# RENESAS TECHNICAL UPDATE

Product Category	MPU/MCU		Document No.	TN-RZ*-A008A/E	Rev.	1.00
Title	Correcting wrong description of Delta Sigma Interface(DSMIF) specification in RZ/T1 Group User's Manual Hardware.		Information Category	Technical Notification		
Applicable Product	RZ/T1 Group	Lot No.	Reference Document	RZ/T1 Group User's Manual Hardware Rev1.0 R01UH0483EJ0100 Rev.1.00		
		All lots

Figure 1.1 Setting Procedure

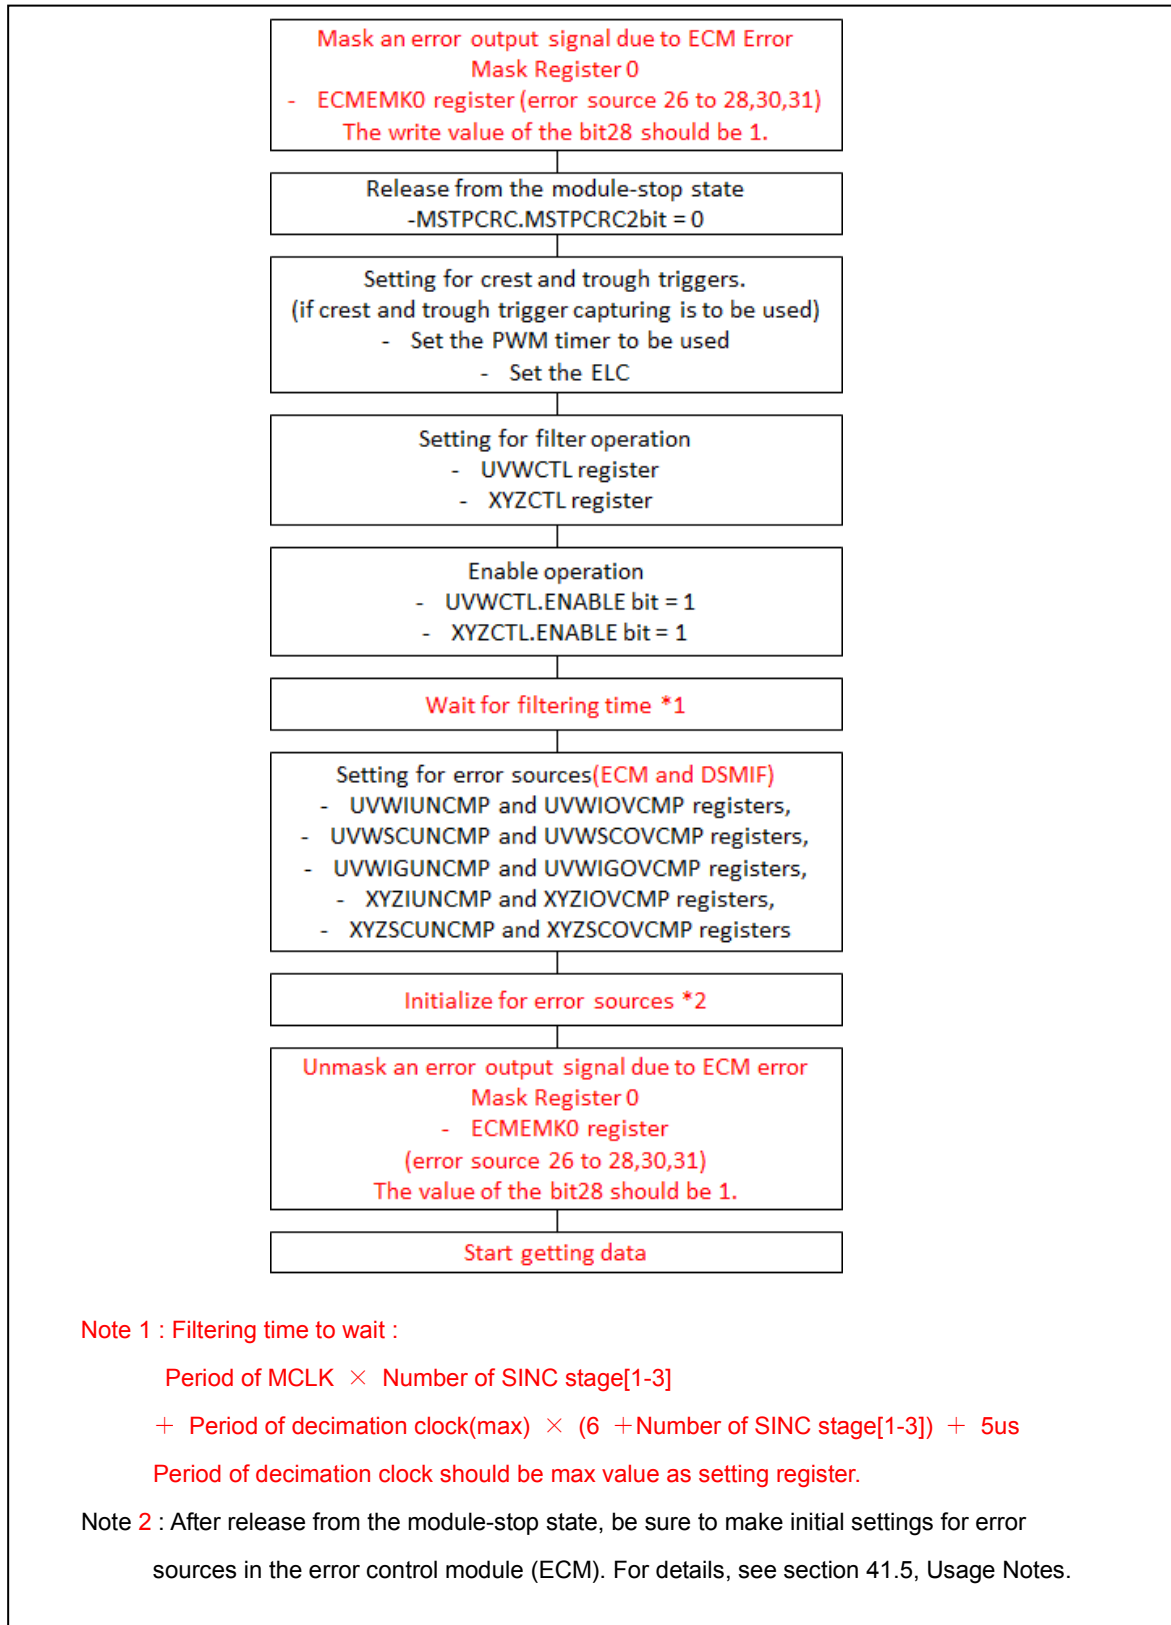
p.2265	XYZ Overcurrent Abnormality Detection Upper Limit Setting Register (XYZIOVCMP)	Address : A007 208Ch	Address : A007 209Ch
p.2278	Figure 41.9	Figure 41.9 in the Users Manual.	Figure 1.1 in this report.

3. Detail of a correction for Fig.41.9 in the User's Manual

The revised points are described in red characters.

The description in black characters is unchanged, but please be noted the total sequence itself is changed.
